SB, Bearing cage, K1270 Rail, 2025-12

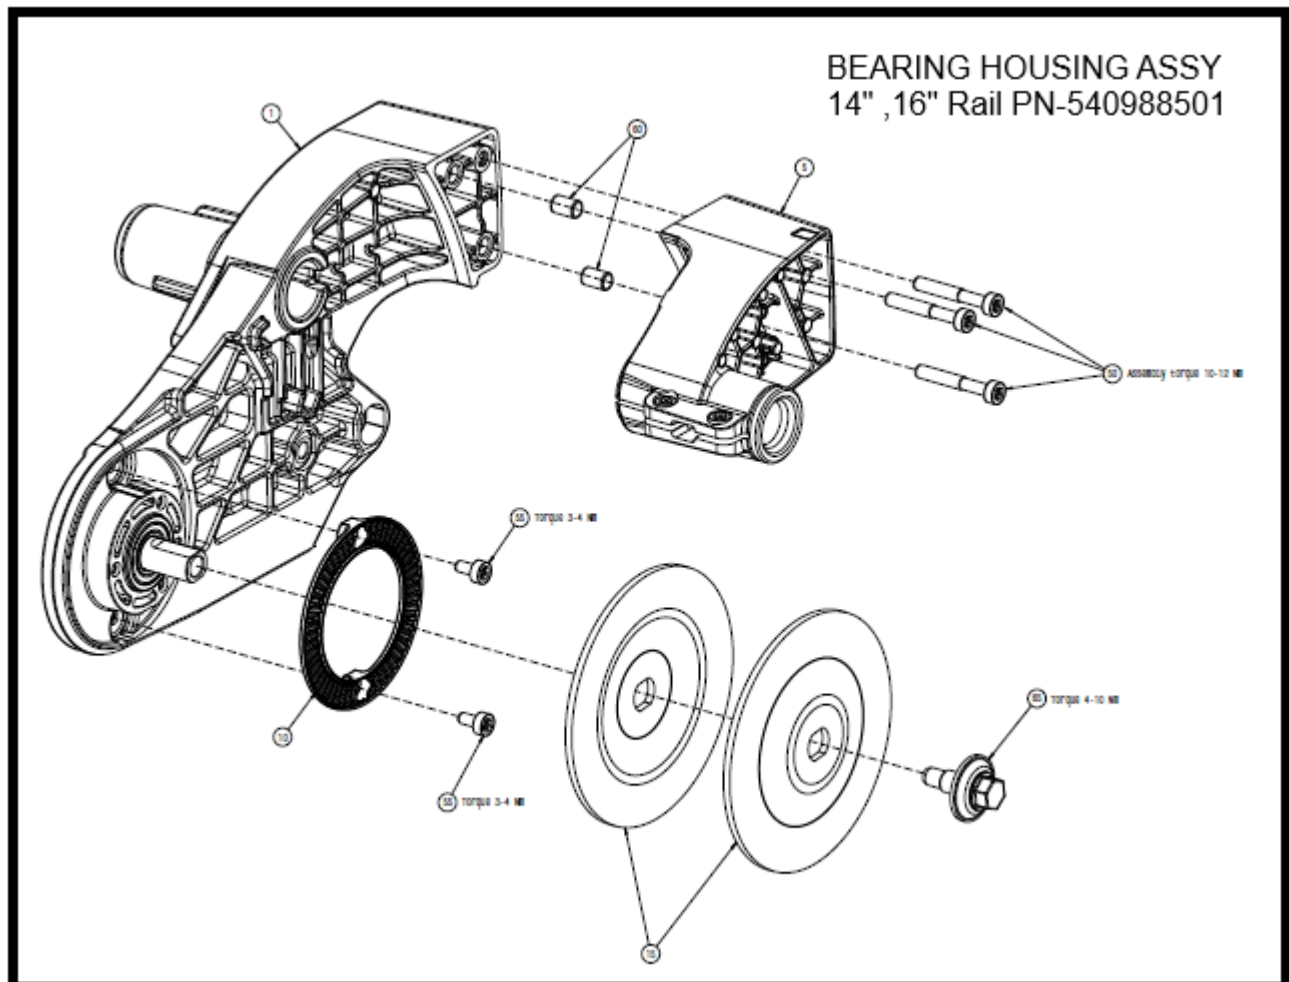
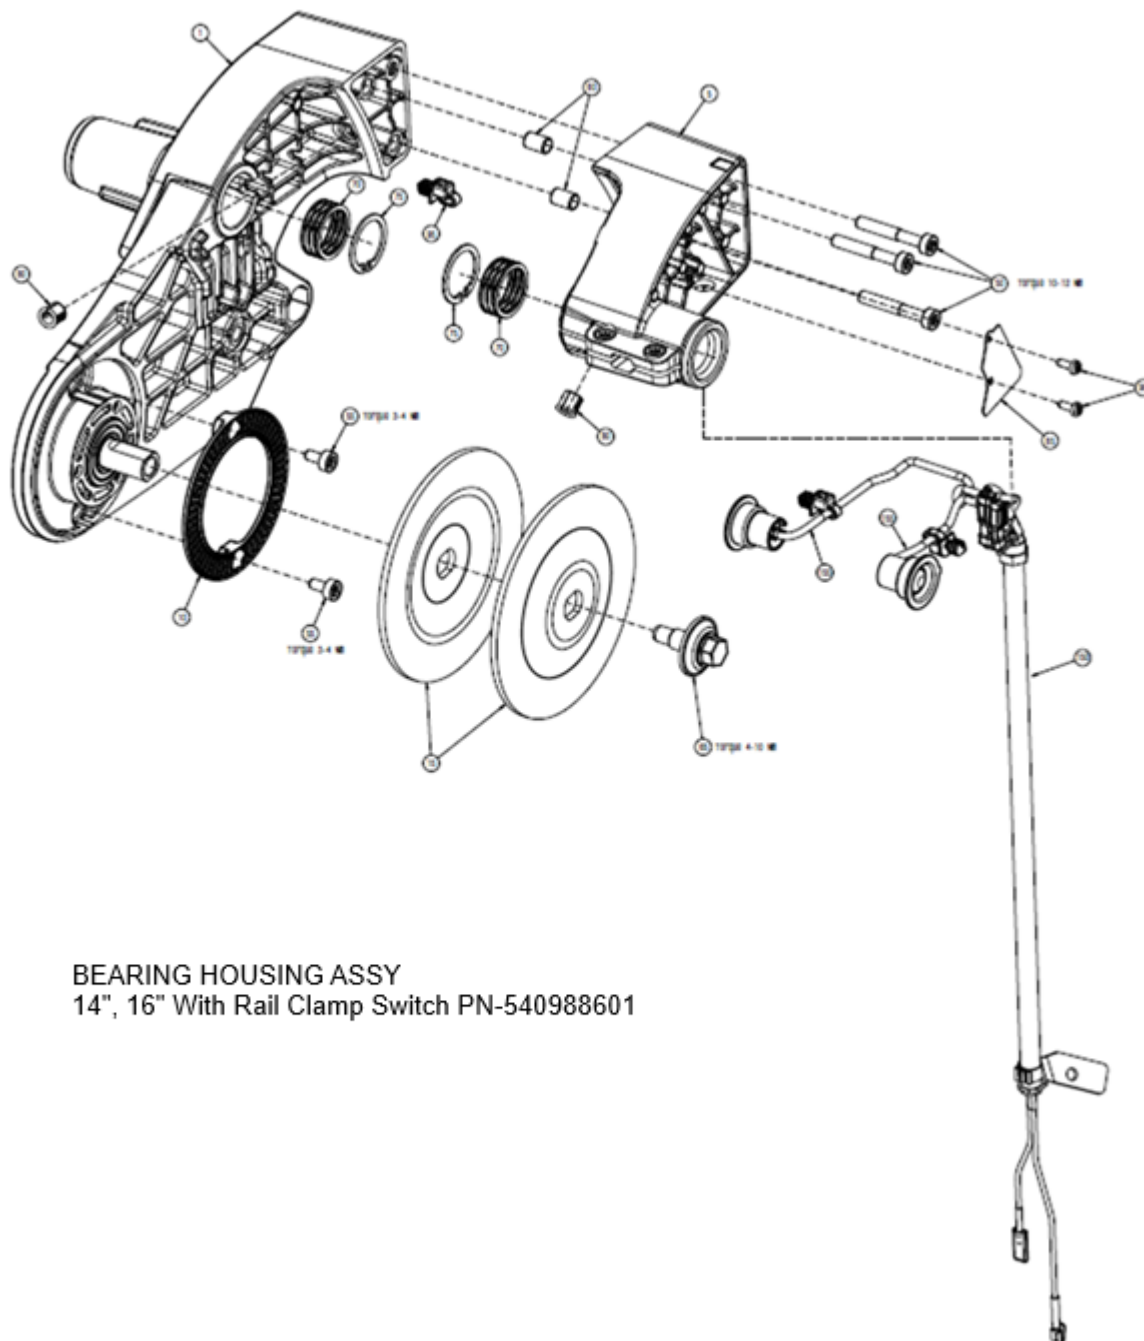
To improve the bearing housing, a new updated bearing housing design is introduced. The new housing is not backward compatible with the existing K1270 rail machines on the market.

Note: When the bearing housing is changed to the updated version, it is required to change the belt guard and use the updated belt. Instead of a separate housing for 14" and 16", the new bearing housing is a standard version replacing both.

No action required for existing machines unless a housing repair or change of parts are needed. A rebuilding Kit is introduced to enable rebuilding the housing for the existing machines when needed. The Kit also includes a new belt guard, a belt tensioner, and a drive belt that need to be changed to the updated version.
